Planning & Zoning Commission Hearing: September 15, 2022

ODP210005, Heartside Hill Overall Development Plan & PDP210020, Heartside Hill Residential Development

Summary of Request

Modification 1 – Park Location

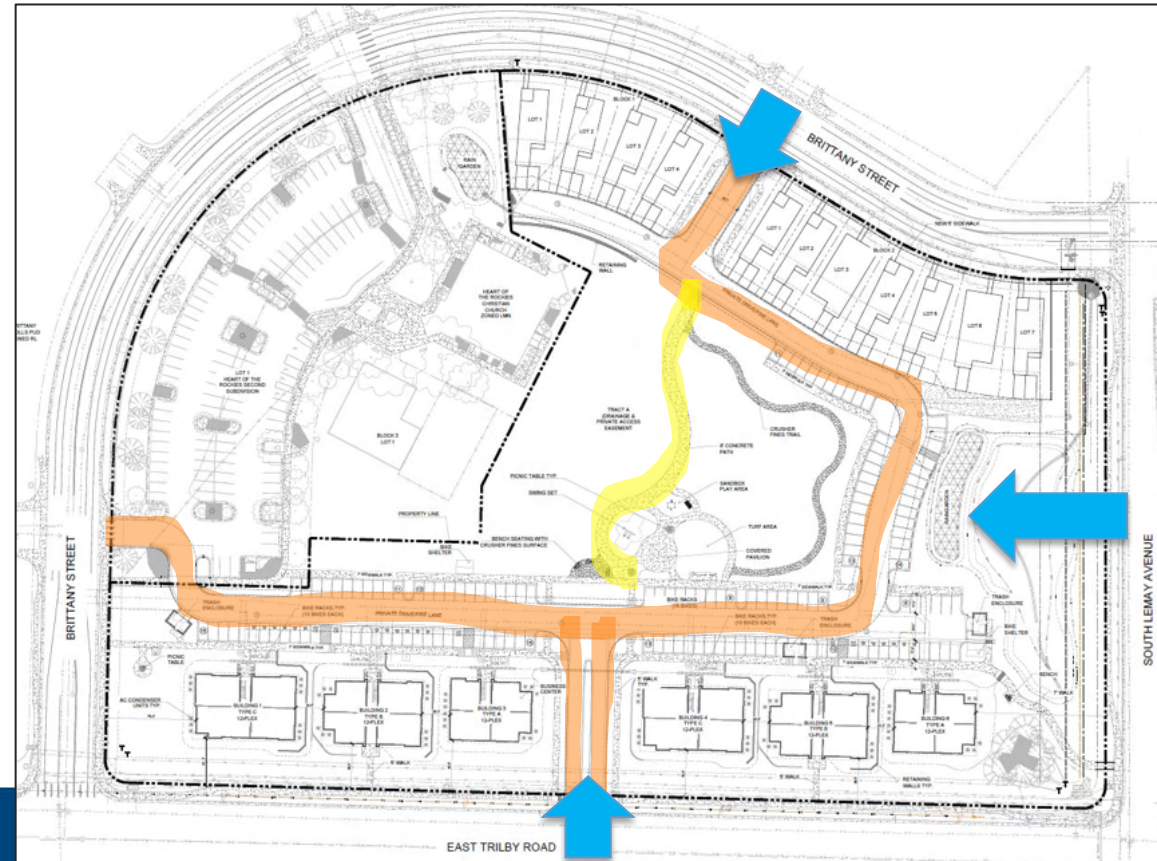
This modification is necessary because the plan's proposed park is not formed by a street pattern in such a way that it is highly visible or easily observed from streets, per location criterion (b).

- **Private Drive**
- **8-foot wide bike/ped connection**
- **Viewpoints from surrounding streets**

- A. The modification meets 2.8.2(H)(1) because the internal network of private drives and sidewalks, the overall site layout, and the proposed 8-foot-wide concrete path promote security, visibility and access to the park thereby ensuring the plan will promote the general purpose of the standard for which the modification is requested equally well or better;

Modification 2 – Block Size

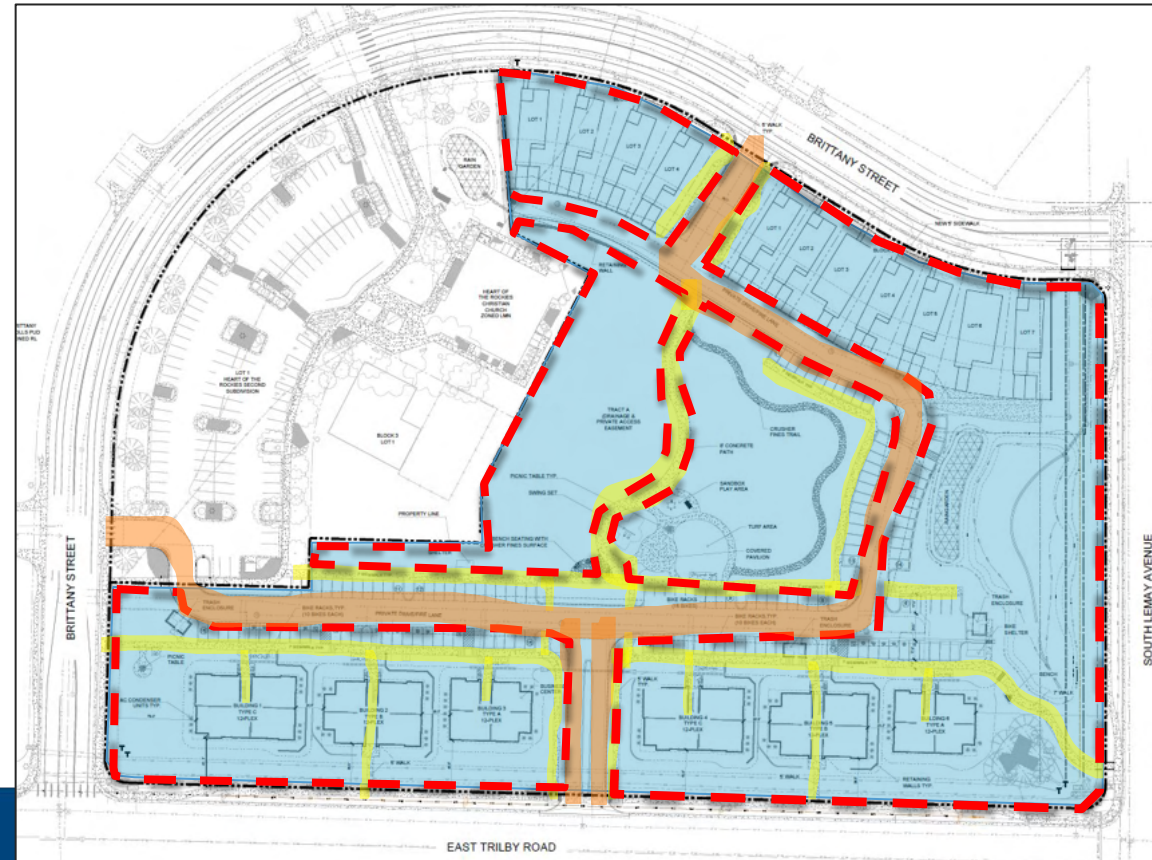
This modification is necessary because the proposed project has a block size which exceeds 7 acres.

- Private Drive
- Walkways
- 8.35 Acre Block
- Informal Blocks

- The Modification of Standard to Section 3.8.30(D)(2) would not be detrimental to the public good and the Modification meets the applicable requirements of Section 2.8.2(H)(1), (2) and (4):
 - Achieves the purpose of the standard (limiting the maximum block size of multi-family developments to 7 acres) **equally well or better** by utilizing the private drive and north/south bike/ped connection to functionally reduce the block size.
 - Project **substantially alleviates a community need** of city-wide concern (i.e. need for affordable housing) and the strict application of the standard would render the project practically infeasible.
 - The deviation from the standard is a **nominal, inconsequential** (i.e. increase of 1.35 acres) when considered from the perspective of the entire development plan.

Modification 3 – Street-Facing Facades

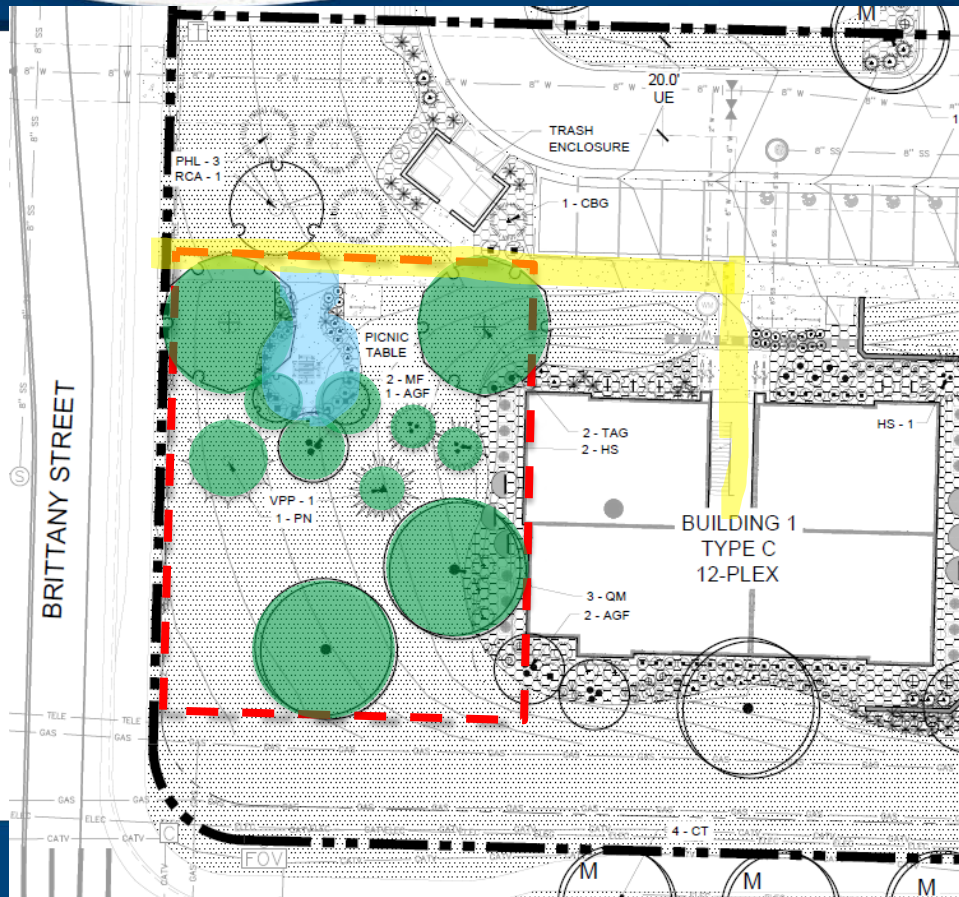
This modification is necessary for the westernmost multi-family building (aka Building 1) because that proposed design does not have a building entrance or doorway facing Brittany St.

- **Modification:** Applicant requests a Modification to Section 3.5.2(D)(2) ***Street-Facing Facades***. Every building containing four (4) or more dwelling units shall have at least one (1) building entry or doorway facing any adjacent street that is smaller than a full arterial or has on-street parking
- **Proposed modification contends that the strict application of the standard would reduce the unit count provided on the site, and that the proposed landscaping and seating amenity area to the west of Building 1 will enhance the façade that faces Brittany St in a way that is comparable to an entrance.**

- **Area of Modification**
- **Additional tree-stocking adjacent to the façade**
- **Connecting walkway to primary entrance**
- **Picnic table amenity area**

- D. The modification meets 2.8.2(H)(1) because the proximity of the primary building entry, the enhanced landscape treatment of the west façade, and the provision of on-site amenities between the building and the street promotes visual interest and orientation of other site elements in a way that will promote the general purpose of the standard for which the modification is requested equally well or better;
